BOARD OF VARIANCE

NOTICE OF OPEN MEETING

(a) **APPEAL NUMBER:** B.V. 6338 **6:00 p.m.**

CIVIC ADDRESS OF PROPERTY: 6279 Service Street

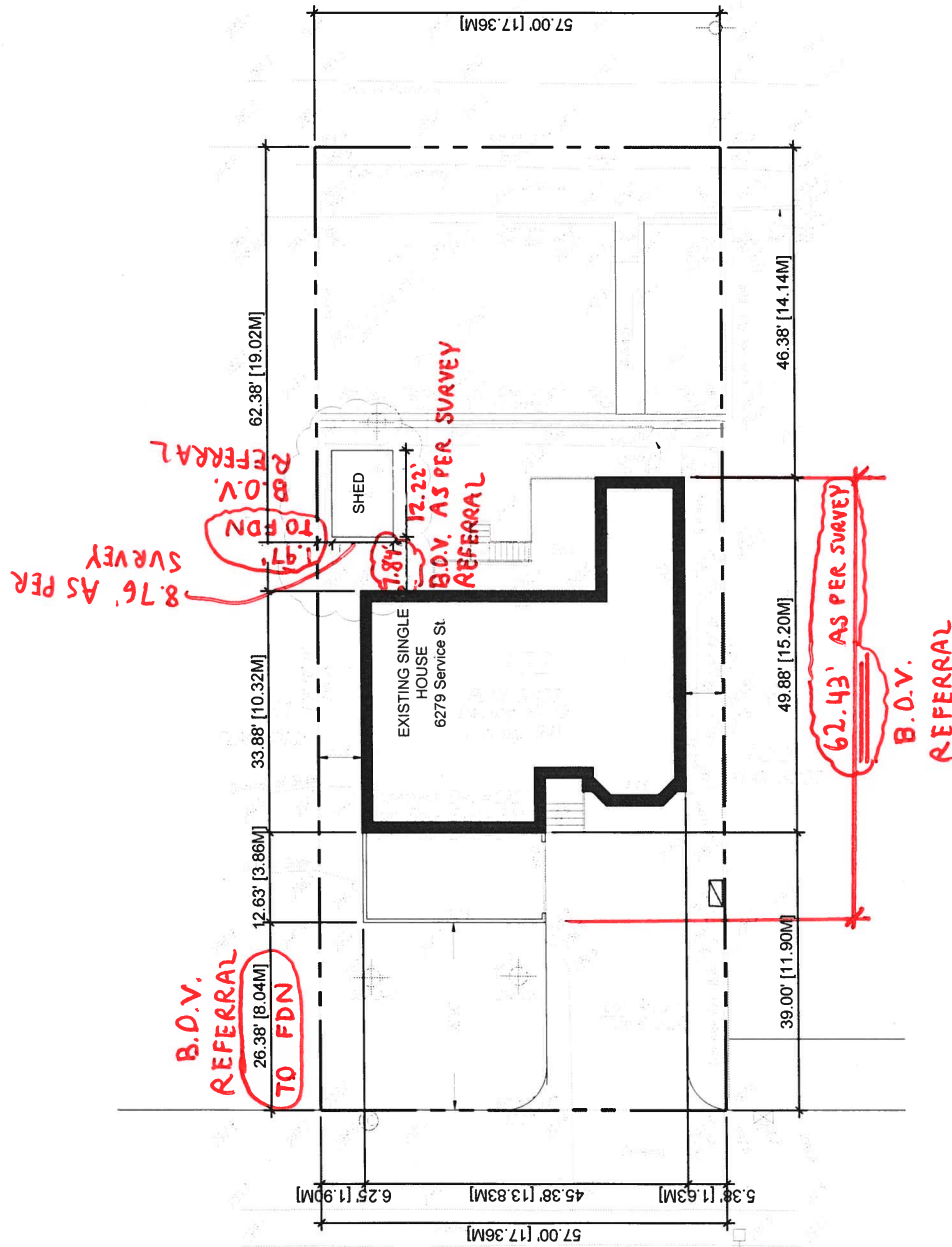
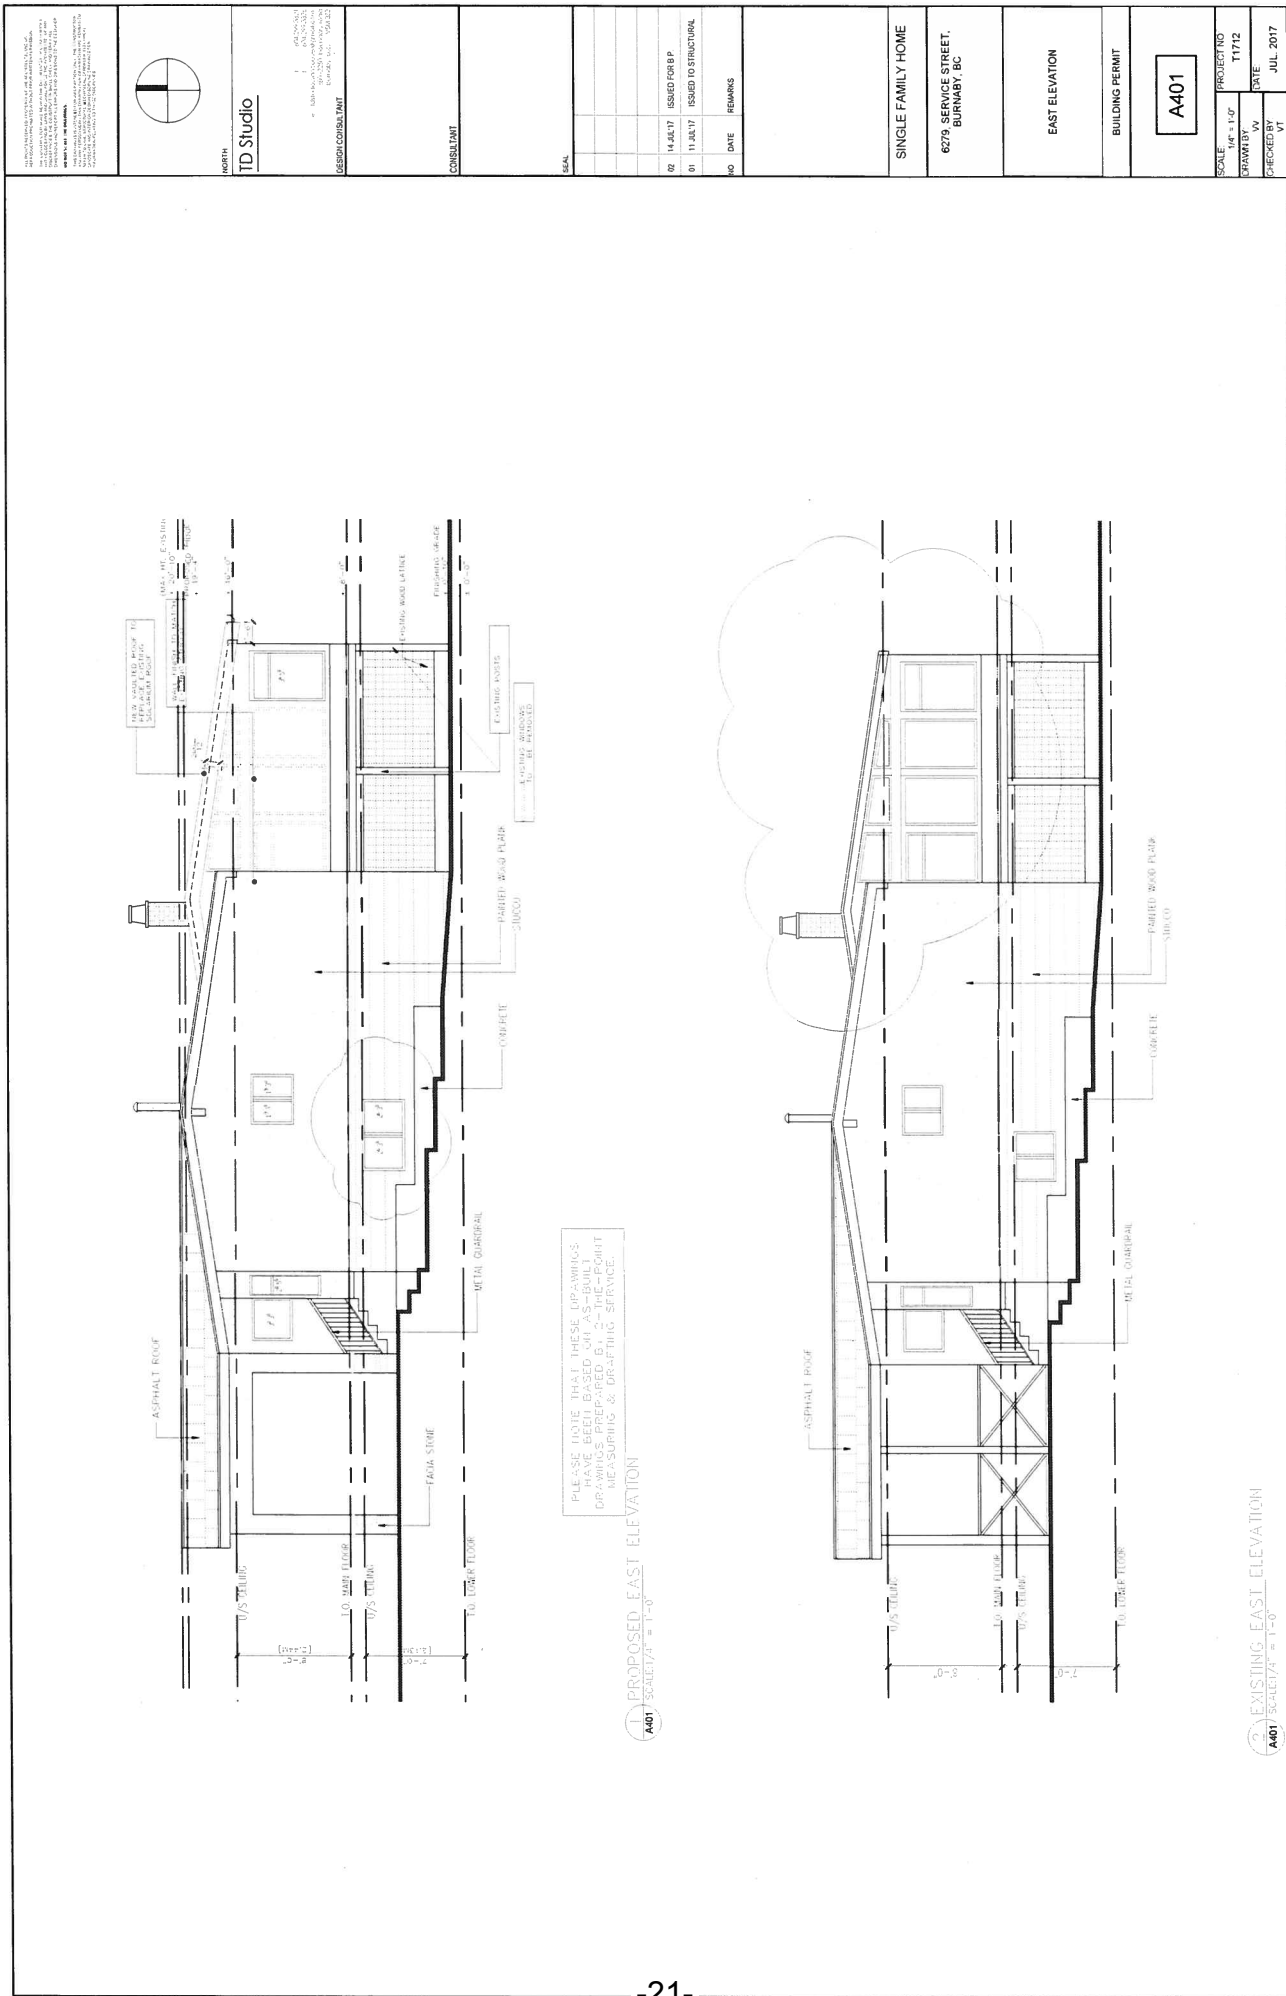
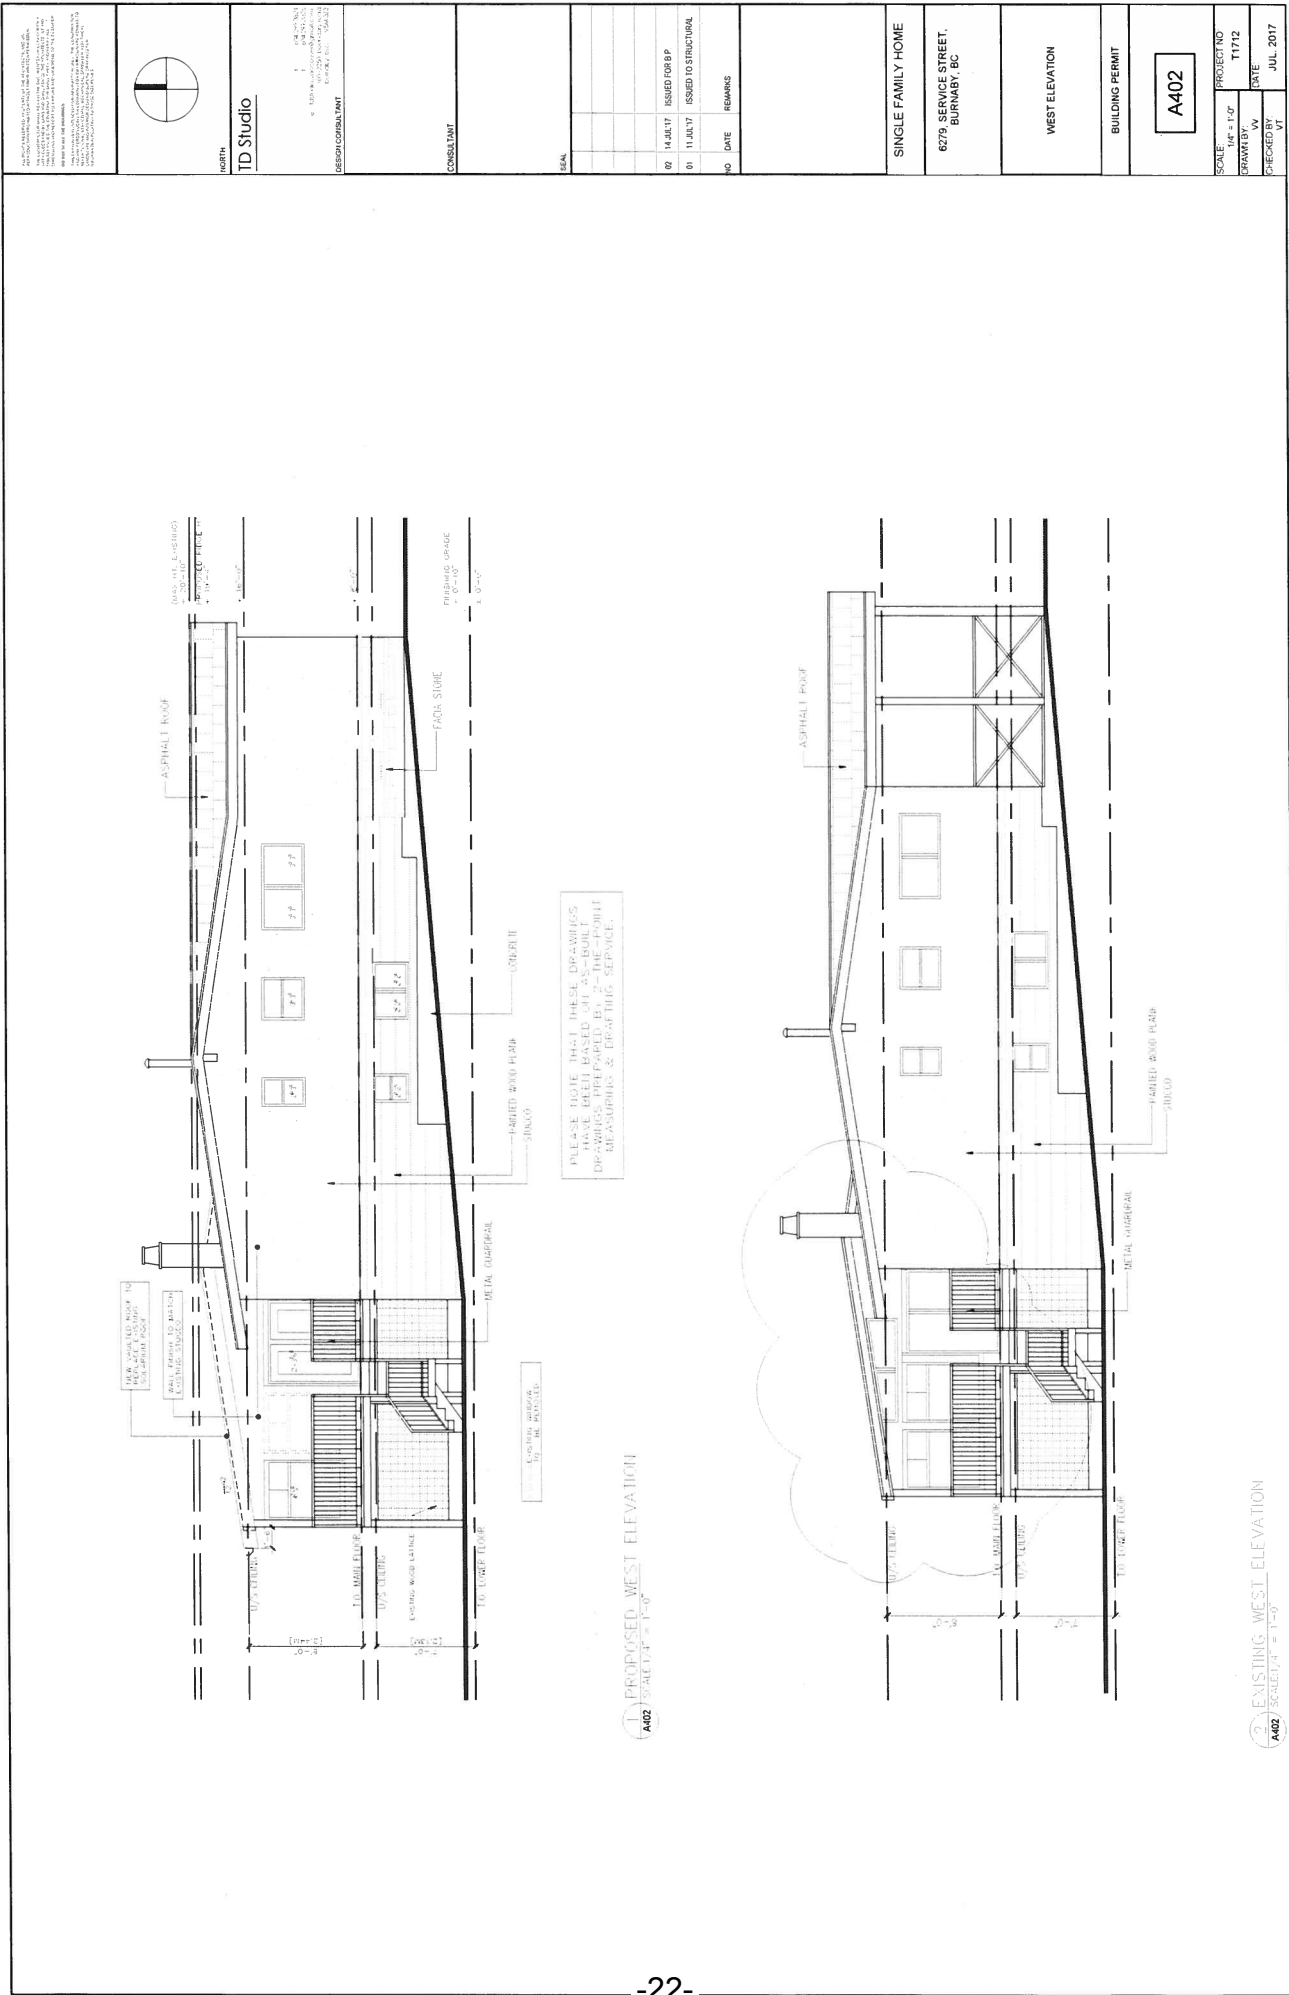
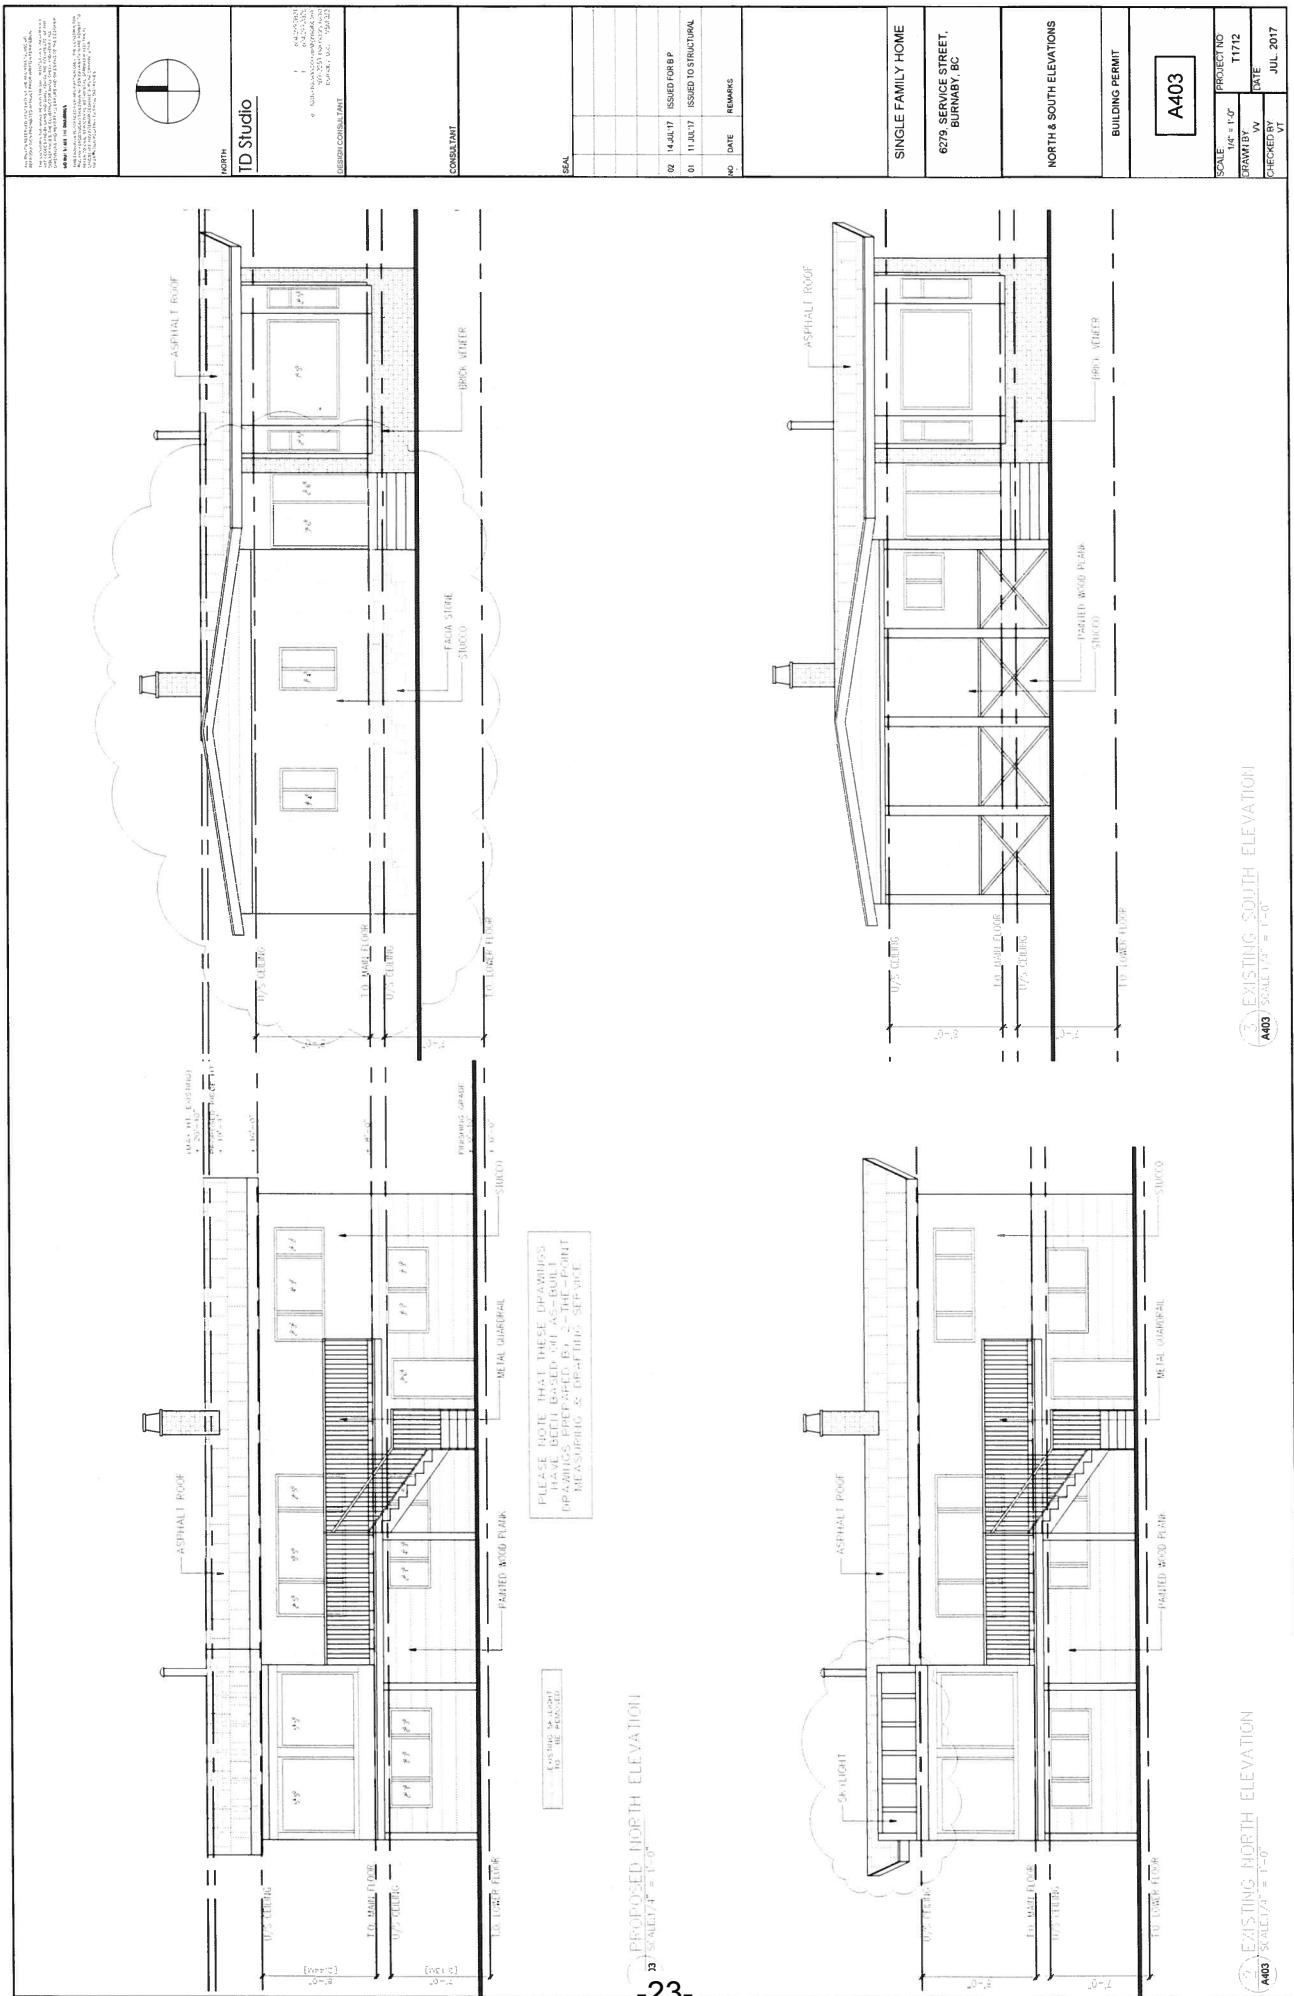
Building Permit application BLD17-01016 will be denied by the Building Department because the design is not in compliance with Burnaby Zoning Bylaw No. 4742:

Zone R4 / Section 6.6(2)(d); 6.3.1; 104.8(1); 104.9

The applicant has constructed interior alterations exterior alterations, an addition at the rear and a new accessory building to an existing single family dwelling without a permit. In order to allow the Building Permit application to proceed, the applicant requests that the following variances be granted:

- 1) To vary Section 6.6(2)(d) – “Accessory Buildings and Uses” of the Zoning Bylaw requirement for the minimum side yard setback from 3.94 feet to 1.97 feet.
- 2) To vary Section 6.3.1 – “Distance between Buildings on the same Lot” of the Zoning Bylaw requirement for the minimum distance from 14.8 feet to 7.84 feet.
- 3) To vary Section 104.8(1) – “Depth of principal building” of the Zoning Bylaw requirement for the maximum building depth from 60 feet to 62.43 feet.
- 4) To vary Section 104.9 – “Front Yard” of the Zoning Bylaw requirement for the minimum front yard depth from 31.25 feet (based on front yard averaging) to 26.38 feet.
